P.O.A.D.P. PLAN

STONE BRIDGE

POADP # 544

The City Staff Development Review Committee has reviewed Stonebridge Subdivision Preliminary Overall Area Development Plan # 544. Please find enclosed a signed copy for your files. Although your plan was accepted, please note the following:

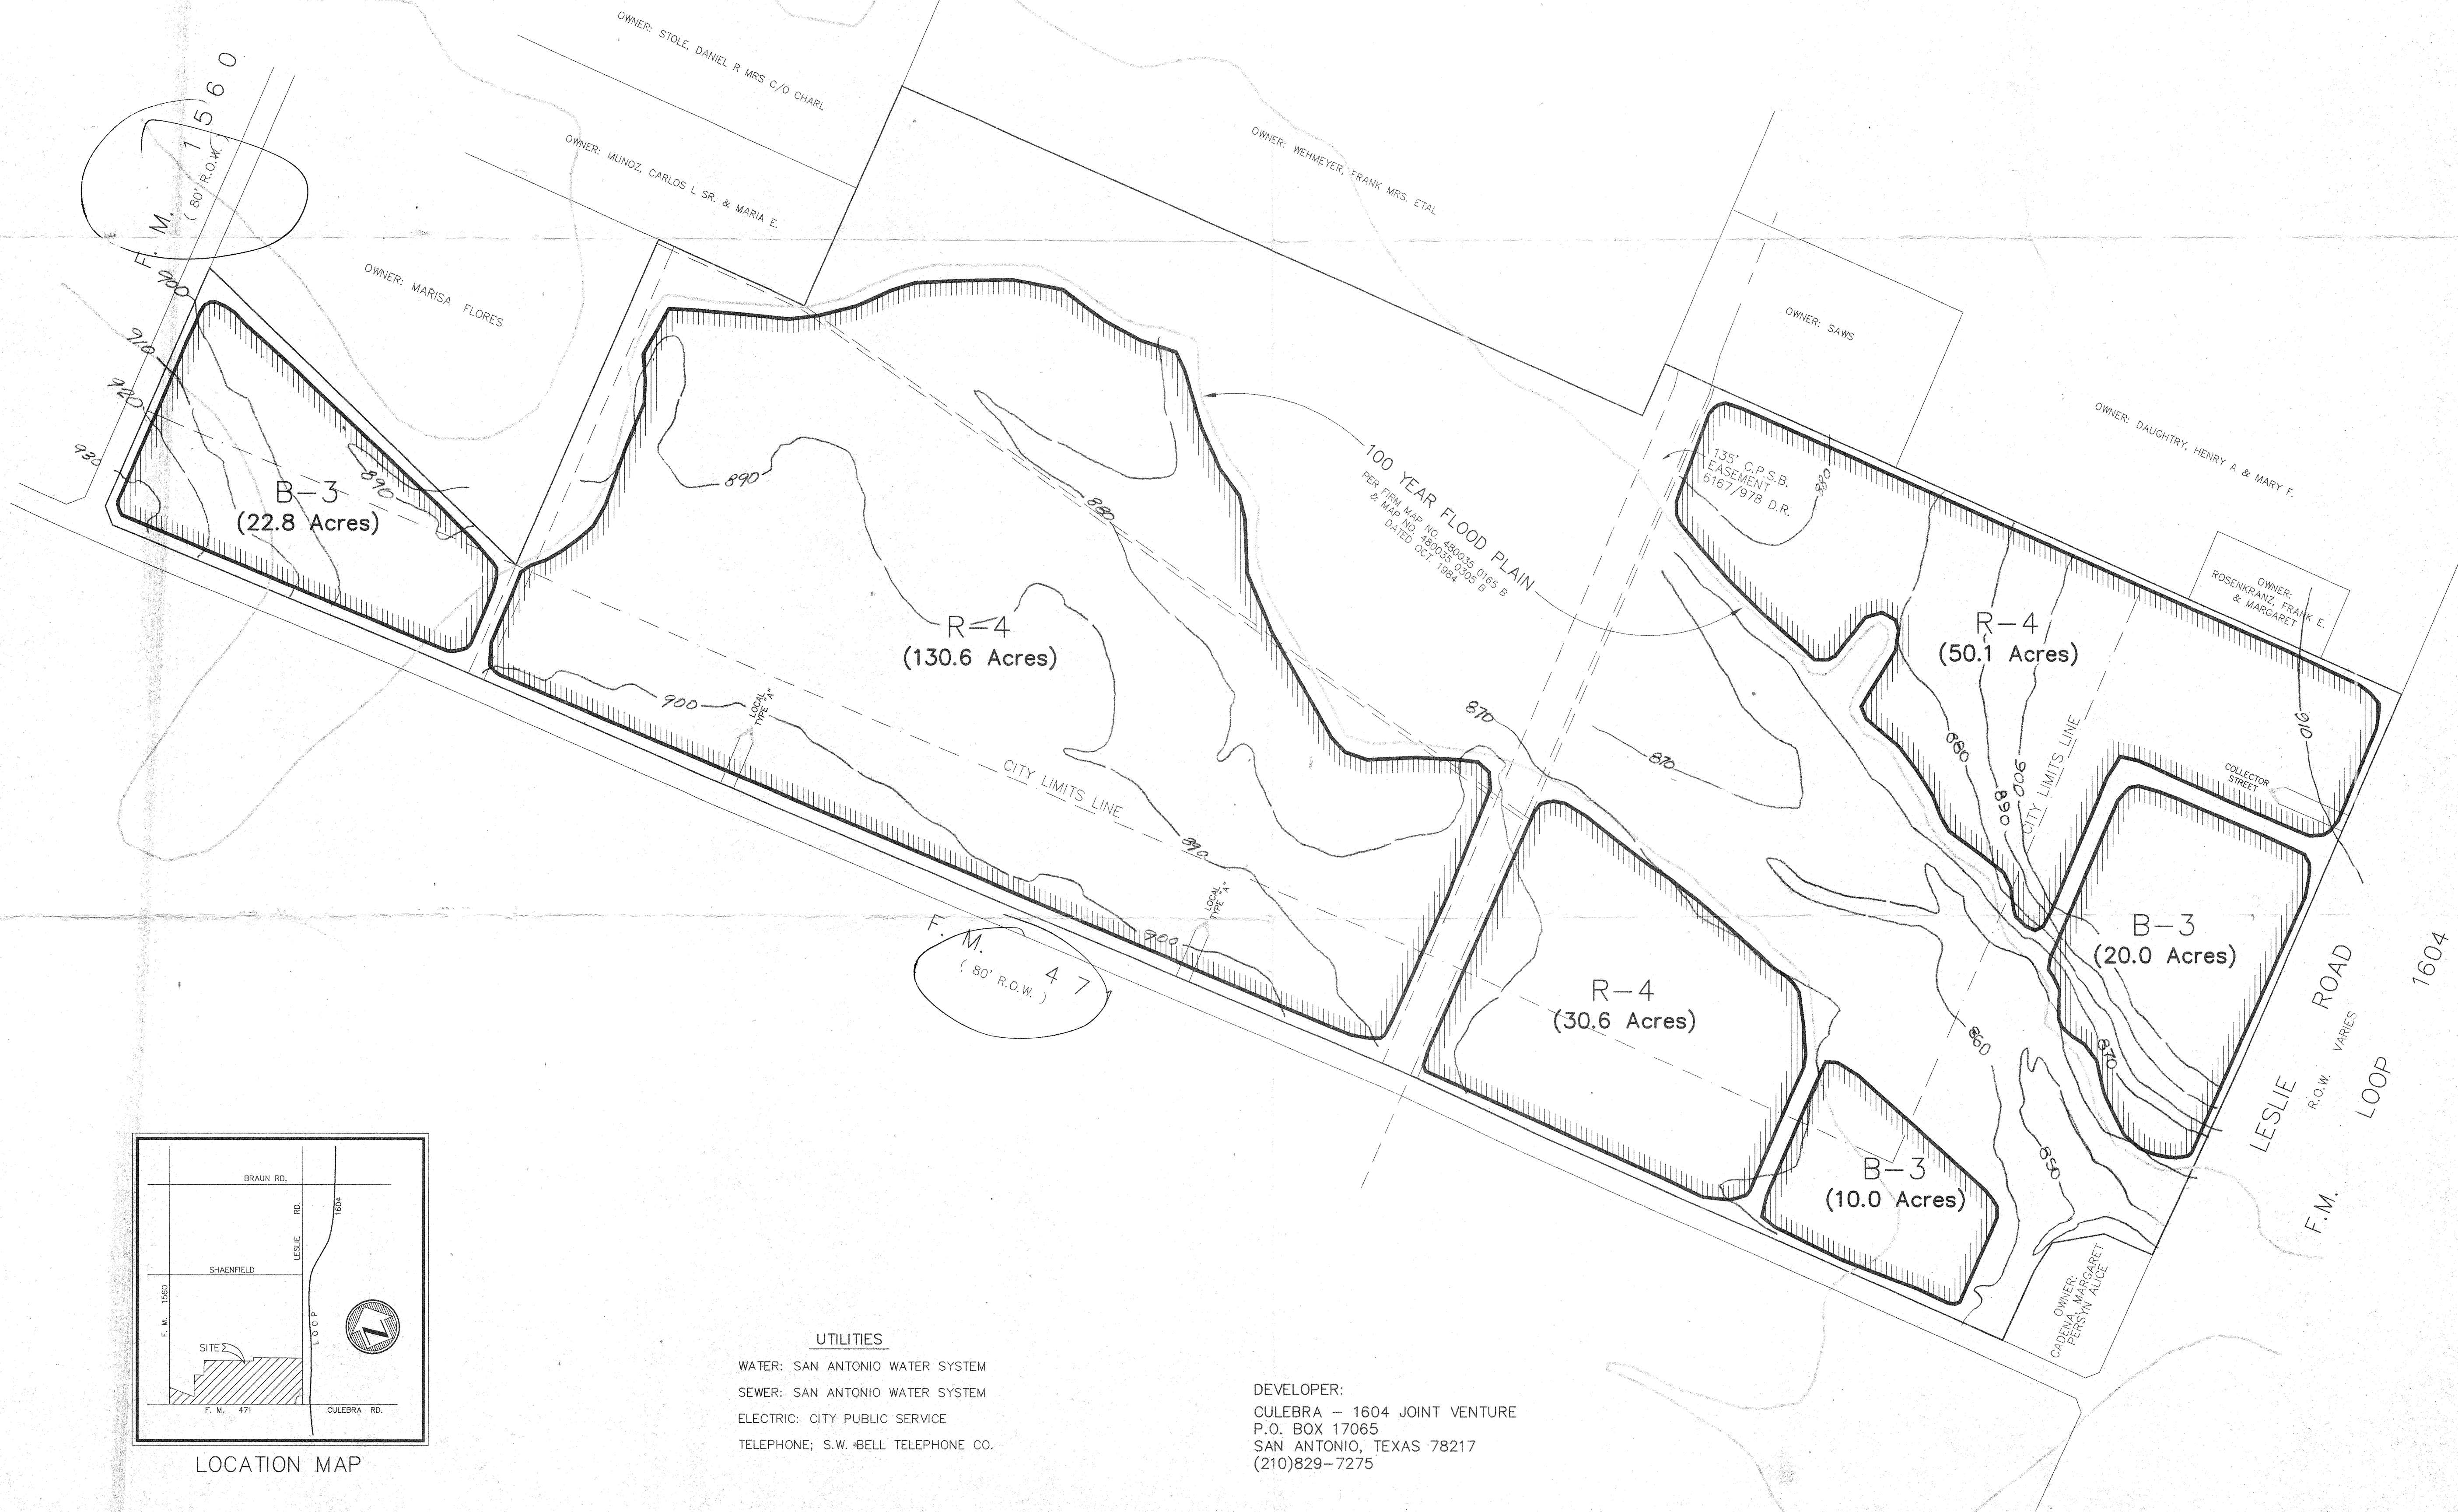
- Based on the topography, a Flood Plain Study and drainage review will probably be required during the platting process.
- Access issues along State facilities will need to be resolved with the Texas Department of Transportation (TXDOT). For additional information about these requirements you can contact TXDOT at 615-5814.

For residential development directly adjacent to State ROW, the developer shall be responsible for adequate set-back and/or sound abatement.

Locations will be as directed by "Regulations For Access Driveways to State Highways". (See attached sheets for access eligibility)

Permit applications along with plans for street, driveway, utility, sidewalk and drainage construction must be submitted to the Texas Department of Transportation for review and approval before working on highway ROW. TxDOT requires that a recorded plat accompany all driveway permit applications. The Owner/Developer is responsible for preventing any adverse impact to the existing drainage system within highway ROW.

ADDITIONAL COMMENTS: As TxDOT develops Loop 1604 into a 4-lane divided facility, mainline crossovers will be constructed at FM 471 & Shaeffer Rd. No additional crossovers will be constructed within these limits.

For residential development, all access will be from planned local collector streets. A 1' non-access easement will be required along the frontage of residential development.

Comments: 1. T/A is required
2. Show Phases
3. Show Approx. densities for each use.
D. Gilani Eng. Associate 12/6/96
Signature Title Date

Comments: FLOOD PLAIN DEVELOPMENT PERMIT AND
DRAINAGE EASEMENTS WILL BE REQUIRE AND
ADDRESS DURING THE PLATTING PROCESS.

The Streets and Traffic Engineering Division has reviewed the Level-2 Traffic Impact Analysis for the rezoning of the 23-acre portion of the previously submitted Stonebridge POADP. By virtue of simply identifying the traffic impacts, it is in compliance with the Traffic Impact Analysis Ordinance 84917.

Originally, this portion of land was estimated to generate 49 peak hour trips based on the 6th edition of the *ITE Trip Generation Manual*. Rezoning this portion to B-3, the peak hour trips (PHT) increase to 992 PHT, a difference of 943 PHT. These 943 trips must be combined with the 976 trips projected to be generated by the adjoining 47 acres of residential and commercial property in the Stonebridge development. The total 1,968 peak hour trips will be distributed through only three access points, all of which will feed the southbound frontage road on Loop 1604.

A solution to this *significant traffic congestion* requires direct access across Culebra Creek to F.M. 471 and points north and/or west.

The above mentioned POADPs do not indicate a phasing plan for the following reasons:

- 1 - The respective owners do not know how they are going to phase their projects at this time; and
- 2 - It is not required by the UDC.
